Access Compliance Report Public Rights-of-Way (Curb Ramps)

Main Street: FARNHAM_LN		Cross Street: MILNEBURG_ST		Location:	SE
ADA ID: RPAT220203105047	Ramp Type: Type 4 - Parallel	Initial Pass/Fail: Fail	Overall Compliance: No	Severity Score:	5
Codes/Mitigation Info/Possible Solution			Field Measurements/Component Compliance

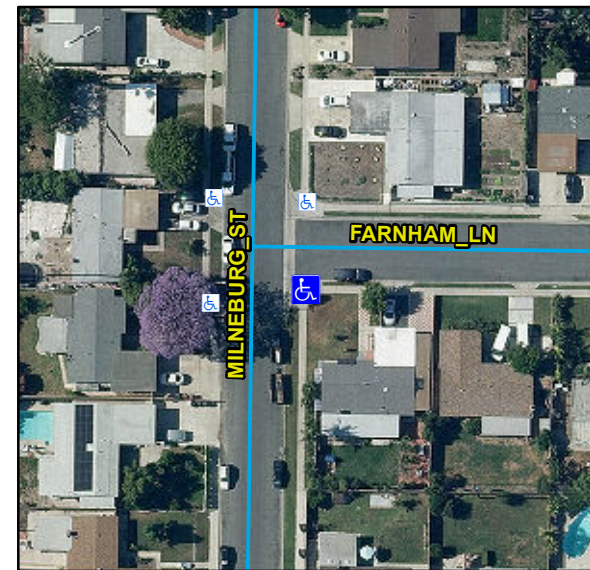
R304.5.1, R304.5.3, STD 1115

Compliance	Description	Data	Compliance	Description	Data
N/A	Ramp Length LT (in)	84	N/A	Ramp Length RT (in)	84
No	Ramp Width LT (in)	43	No	Ramp Width RT (in)	44
Yes	Ramp Run Slope LT (%)	7.2	Yes	Ramp Run Slope RT (%)	4.9
No	Ramp Cross Slope LT (%)	3.4	No	Ramp Cross Slope RT (%)	4
N/A	Landing Present	N/A	N/A	DWS Provided	N/A
N/A	Landing Length (in)	N/A	N/A	DWS Contrast	N/A
N/A	Landing Width (in)	N/A	N/A	DWS Length (in)	N/A
N/A	Landing Run Slope (%)	N/A	N/A	DWS Full Width	N/A
N/A	Landing Cross Slope (%)	N/A		DWS Offset Type	N/A
N/A	Landing Movement Obstructed?	N/A	N/A	DWS Offset Left (in)	N/A
	Landing Movement Type	N/A	N/A	DWS Offset Right (in)	N/A
N/A	Landing Shared	N/A			
N/A	Clear Space	Yes			
N/A	Clear Space To Crosswalk (in)	N/A			
N/A	Marked Crosswalk 1	No	N/A	Marked Crosswalk 2	No
	Crossing 1 Direction	N		Crossing 2 Direction	W
	Marked Crosswalk 1 Width (in)	N/A		Marked Crosswalk 2 Width (in)	N/A
N/A	Ramp Inside Crosswalk 1	N/A	N/A	Ramp Inside Crosswalk 2	N/A

Remove & Replace Curb Ramp With Two New Directional Ramps or Equivalent.
